Software Bulletin

cobas® 6000 analyzer series – Software Version 05-02 Upgrade

Figure 2. System Overview screen - cobas pack without partner pretreatment cobas e pack

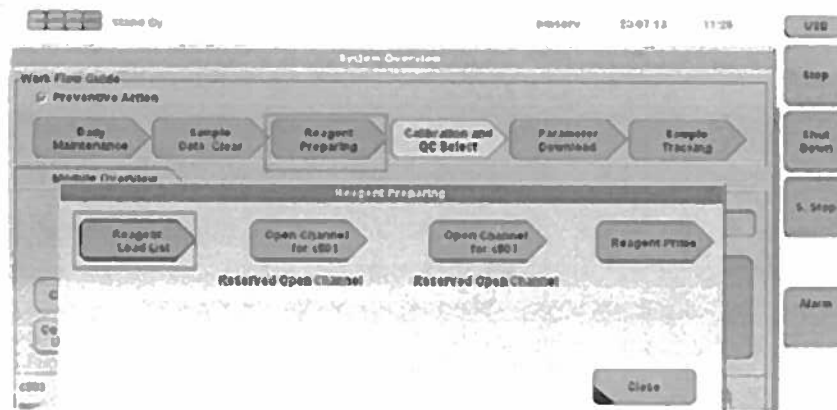
System Overview screen: Required pretreatment **cobas e** pack is missing (Figure 2).

- The Module button for the **cobas e** 601 module in the Module Overview area turns red.
- The Reagent Preparing button in the Work Flow Guide area turns red.
- The Reagent Load List button in the Reagent Preparing window turns red. The Reagent Load/Unload List will indicate which **cobas e** pack is missing.

Figure 3. Reagent Overview screen - assay cobas e pack without partner pretreatment cobas e pack

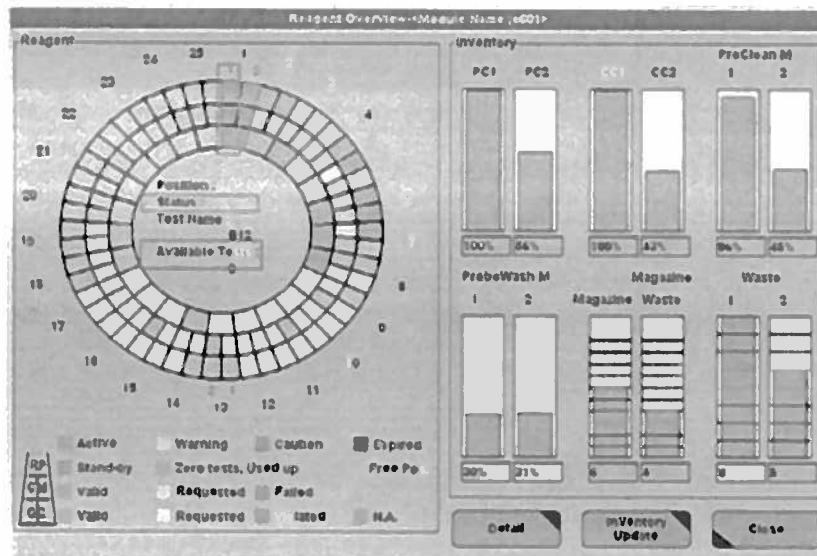
Reagent Overview screen: Required pretreatment **cobas e** pack for B12 assay is missing (Figure 3).

- The **cobas e** pack is marked as "RP: Caution (red)."
- No status (e.g., current, SB1) is displayed.
- Available Tests are zero, although in this example, the B12 assay **cobas e** pack is new and full.

Figure 5. Detail window - linked cobas e pack has been removed with partner cobas e pack still on board

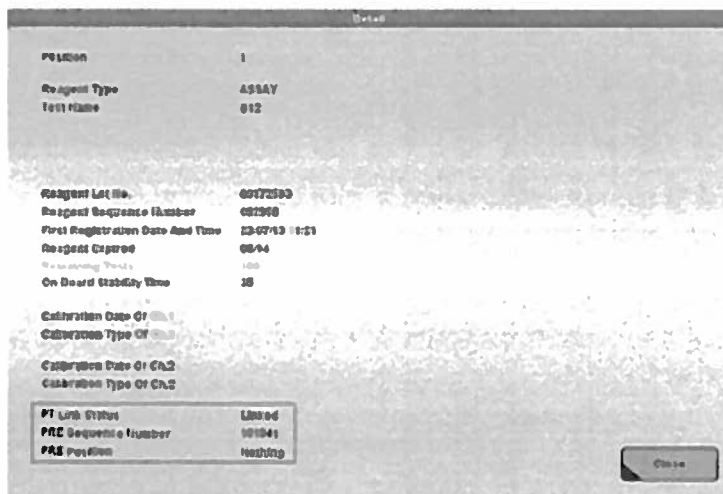
If a linked assay **cobas e** pack or pretreatment pack is removed from the reagent rotor and the partner pretreatment pack or assay **cobas e** pack is still on board, the software acts similar to the examples when an assay **cobas e** pack/pretreatment pack did not have its required partner pretreatment/assay **cobas e** pack. The only difference is found in the Detail window. (See Figure 5 on the next page.)

- PT Link Status is “Linked.” Both the assay **cobas e** pack and the pretreatment pack are linked to each other and cannot be linked to another pretreatment pack or assay **cobas e** pack.
- Sequence Number is 101841 (as an example). This is the sequence number of the linked partner pretreatment pack.
- Position is “Nothing” because the linked partner pretreatment pack is not on board. It is impossible to display a position number if the partner **cobas e** pack is not on board.

Figure 6. Alarm Setting window - Utility > System (Page 1/4) > Alarm

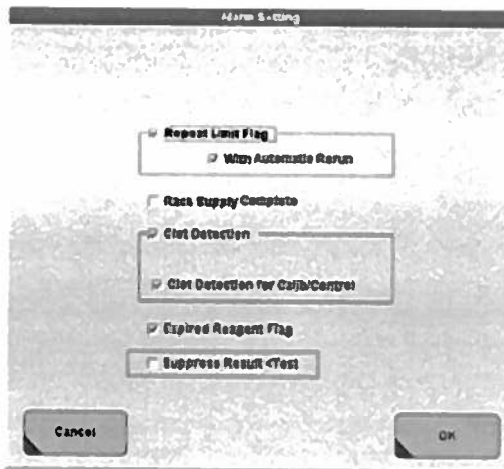
The 05-02 software has a new function, “Suppress Result <Test,” located in the Alarm Setting (Utility > System [Page 1/4] > Alarm), that must be activated to meet this requirement.

Figure 8. Media Write Button in Print View window (Print [global button] > View)

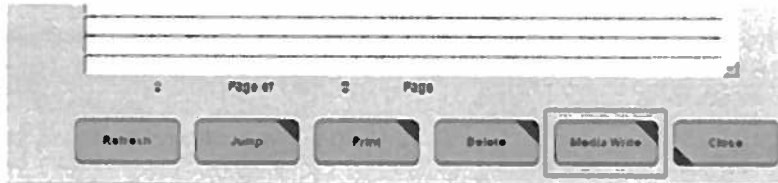
In the Print View window, the button name has changed from Floppy Disk Write to Media Write (Figure 8).

Figure 9. Media Write window (Print [global button] > View > Media Write)

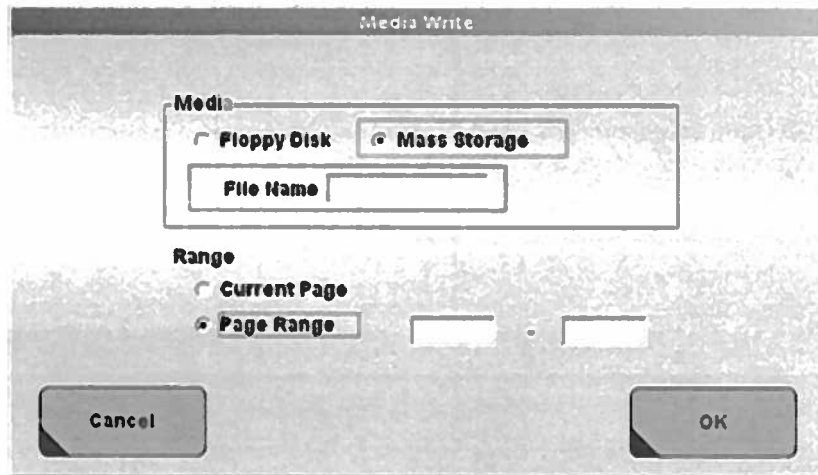
The Floppy Disk Write window name has been changed to Media Write. In the Media area of the Media Write window, you can choose between Floppy Disk or Mass Storage. Mass Storage should be selected when using USB storage devices (Figure 9), and for DVDs.

Figure 10. Parameter Read/Write window (Utility > Maintenance > Maintenance [Maintenance Type] > (15) Parameter Read/Write > Select)

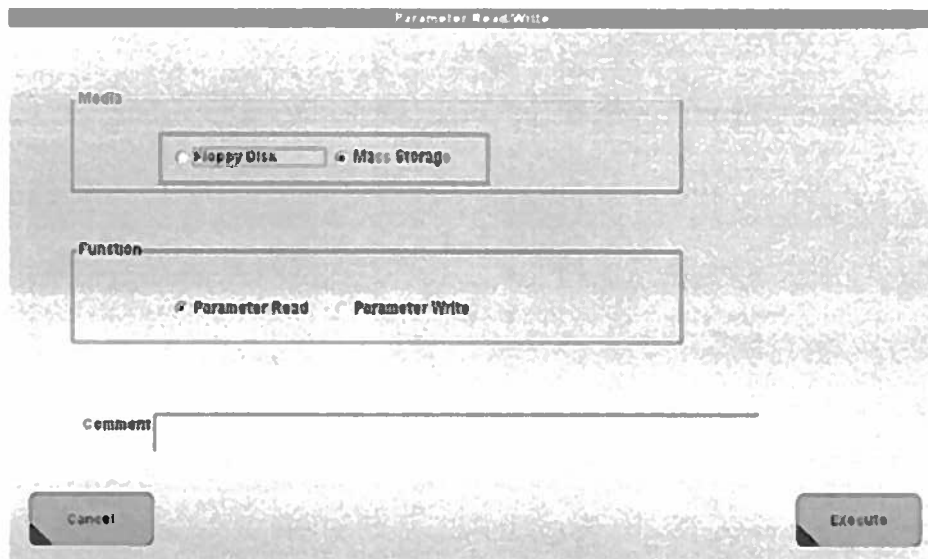
In the Parameter Read/Write window, there is a new Media area to choose between Floppy Disk and Mass Storage (Figure 10).

Figure 11. Check Disk window (Utility > Maintenance > Check [Maintenance Type] > (1) Check Disk > Select)

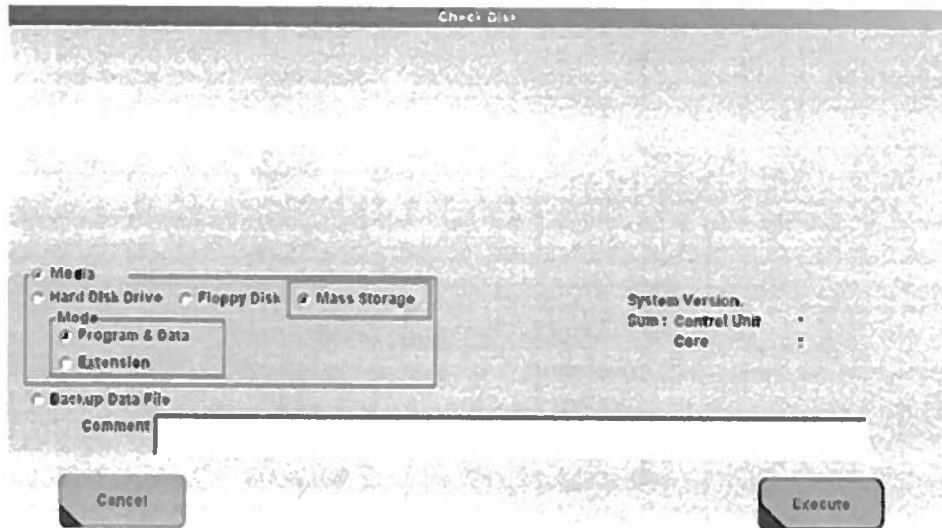
In the Media area of the Check Disk window, the Zip option is changed to Mass Storage (Figure 11). If you select this option, the instrument checks files on the DVD or USB storage device:

- If a USB storage device is inserted, the instrument uses the USB as mass storage.
- If no USB storage device is inserted, the instrument uses a DVD as mass storage.

Figure 12. Global USB button

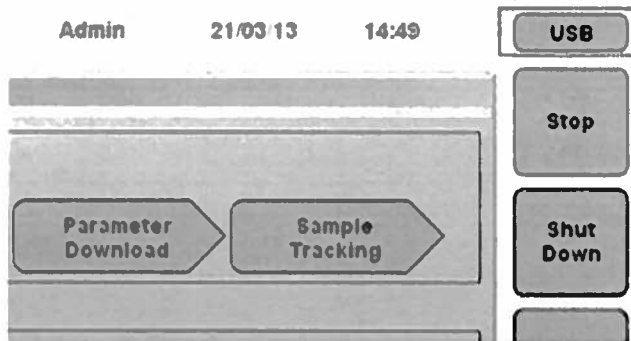
A new global USB button is implemented for using USB storage devices. Follow the steps below for removing a USB storage device using the global USB button.

Figure 23. Confirmation window for overwriting data with new calibrator lot on cobas c 501 module

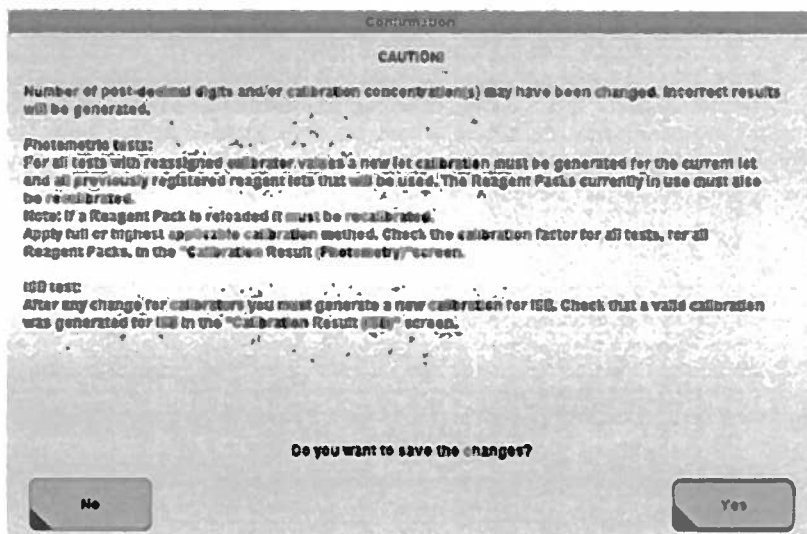
If calibrator data for an existing calibrator code for the **cobas c 501** module is updated with data of a different lot via the **cobas** link (Calibration > Install > Download), a Confirmation window is displayed. In addition to new “Calibrator Code” and “Expiration Date” fields in the Download Parameters section, there are changes in confirmation wording (Figure 22). After pressing OK, another confirmation window appears (Figure 23).

Figure 24. Confirmation window for new calibrator data for cobas e 601 analyzer

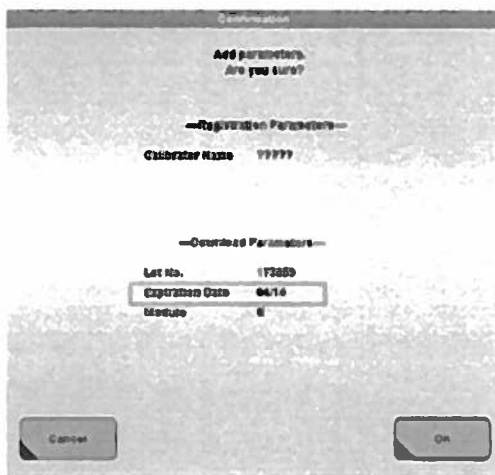
If calibrator data for a calibrator code not currently loaded on the **cobas e 601** module is downloaded via the **cobas®** link (Calibration > Install > Download), a Confirmation window is displayed. In the Confirmation window for calibrator downloads for the **cobas e 601** analyzer, the "Calibrator Name" field has been replaced with the "Expiration Date" field under the Download Parameters section.

Figure 25. Confirmation window updated calibrator data for new lot on cobas e 601 module

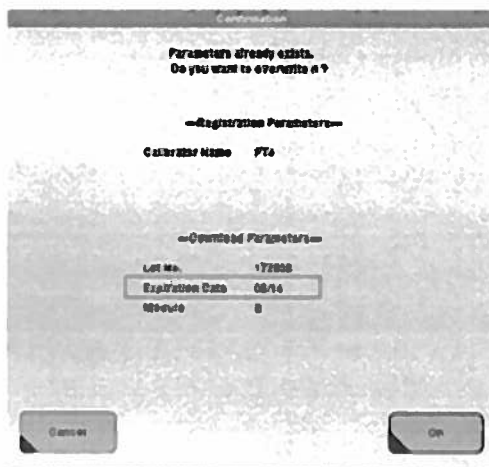
If calibrator data for an existing calibrator code for the **cobas e 601** module is updated with data of a different lot via the **cobas®** link (Calibration > Install > Download), a Confirmation window is displayed. The “Calibrator Name” field has been replaced with “Expiration Date” field in the Download Parameters section.

Figure 26. Confirmation window after manually editing calibrator value on cobas c 501 module

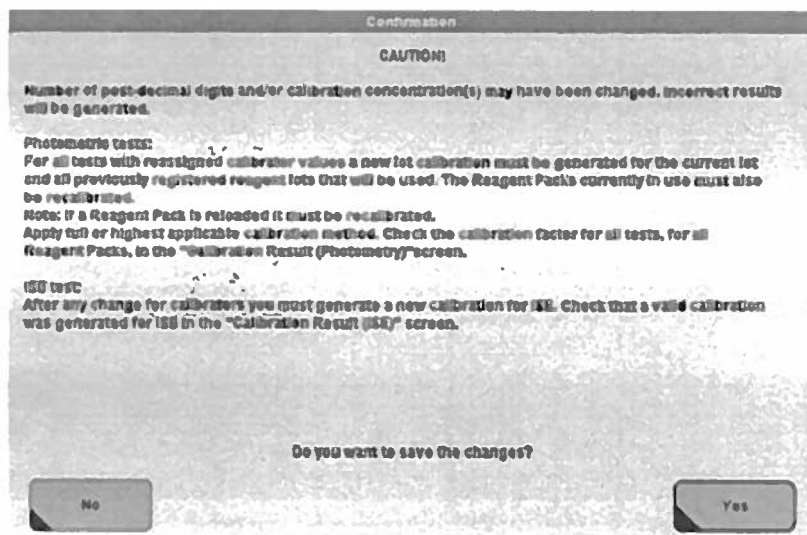
If calibrator values are edited manually in Calibrator > Install/Chemistry > Edit calibrator window, a Confirmation window is displayed. More detailed information has been provided for Photometric tests and ISE tests.
